Subject: Description of Permissive Change

FCC ID: 2AK23MC210

Model Name: MC210, MC210BS, MC210TS, MC210SP, MC210KL, MC210LT, MC210BK

1. The board is different:

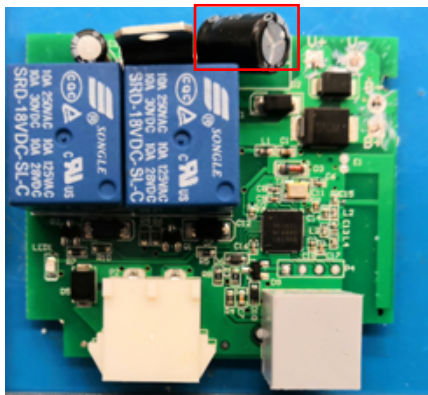
Added: R11, R12, R13, D20, D21, C19.

2. The changes are not related with the other RF parameters, only radiation emissions and conduction emission were retested
